IEEE 802.3cg
Unbalanced PLCA Issue
September 2018

Unbalanced PLCA Issue (comment 613)

Unbalanced Bandwidth

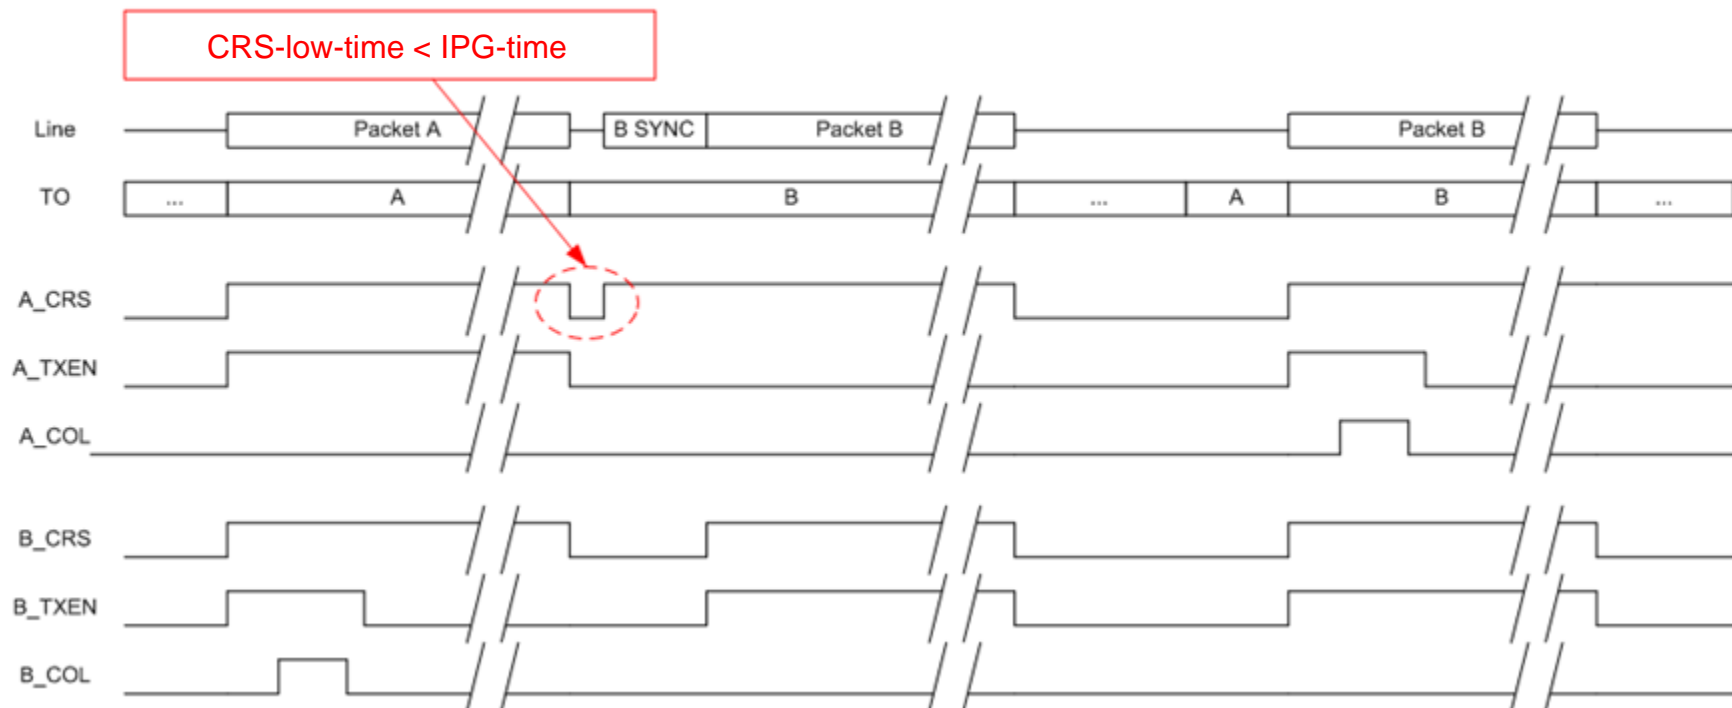
- What we see instead, is:

Bus cycle	1		2		3		4		5		6		7		8	
TO	A	B	A	B	A	B	A	B	A	B	A	B	A	B	A	B
Node A	TX	-	-	COL	TX	-	-	COL	TX	-	-	COL	TX	-	-	COL
Node B	COL	TX	-	TX	COL	TX	-	TX	COL	TX	-	TX	COL	TX	-	TX

→ An unevenly balanced bandwidth distribution like this would render PLCA hardly predictable!

Proposal

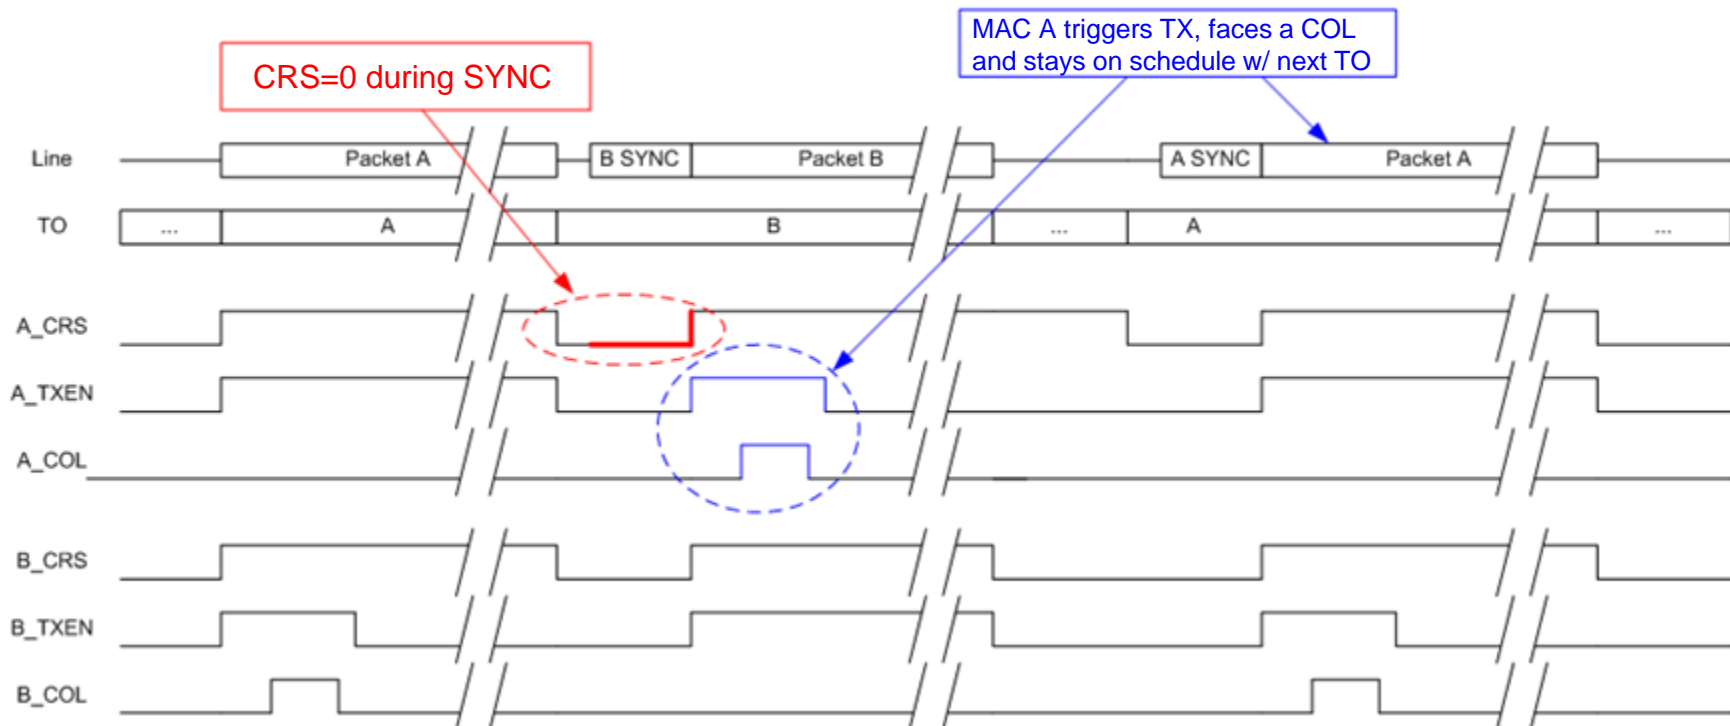
- According to the current spec, PLCA RS will de-assert CRS only for a short time, smaller than the required minimal IPG time
- MAC of node A will not be capable to start transmission of its next pending packet during this period, and may lose its next TO

- Always de-assert CRS between two adjacent packets for at least the min. IPG time
- We can achieve this by keeping CRS de-asserted also during the PLCA SYNC period

Resulting Spec Change

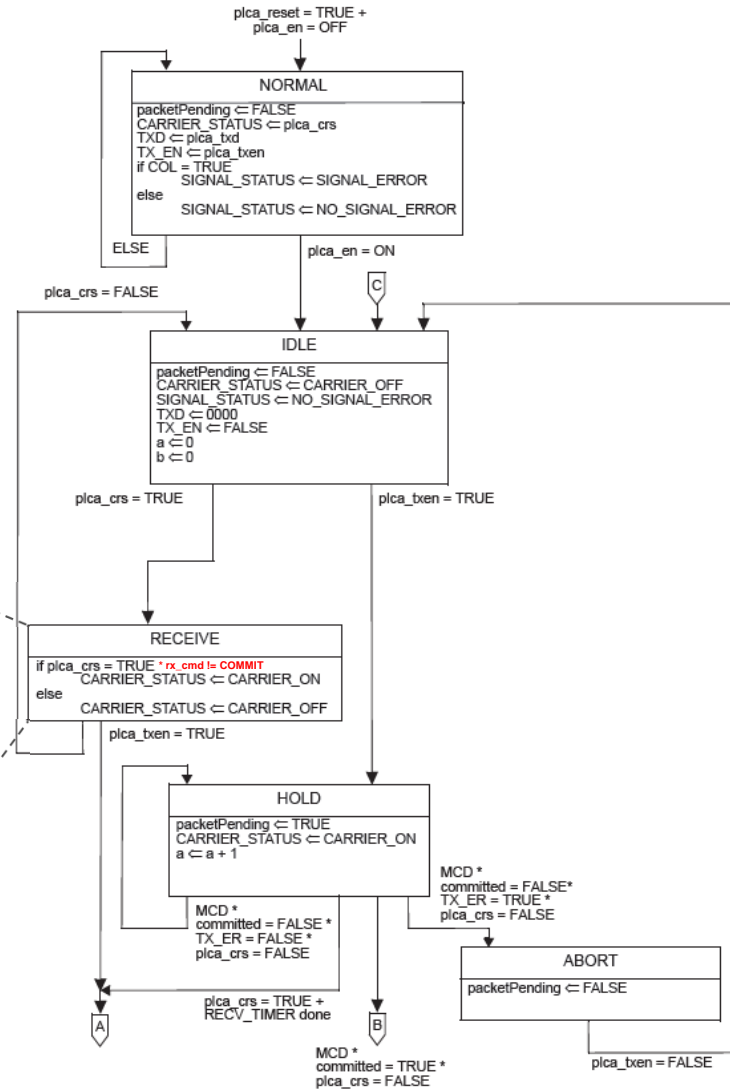
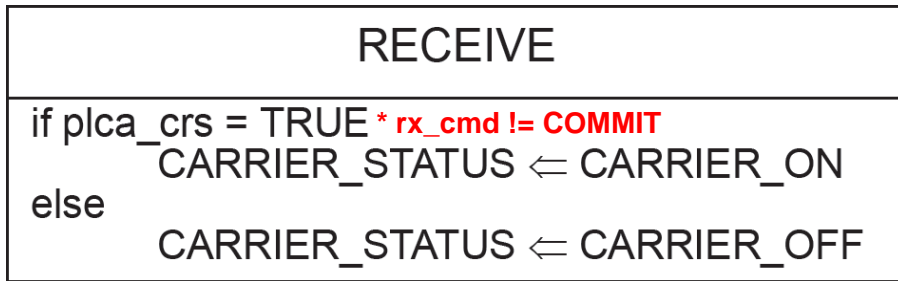
- In Figure 148-6 (IEEE Draft P802.3cg/D2.0)
 - Change “if *plca_crs* = TRUE”
 - to “if *plca_crs* = TRUE * *rx_cmd* != COMMIT”
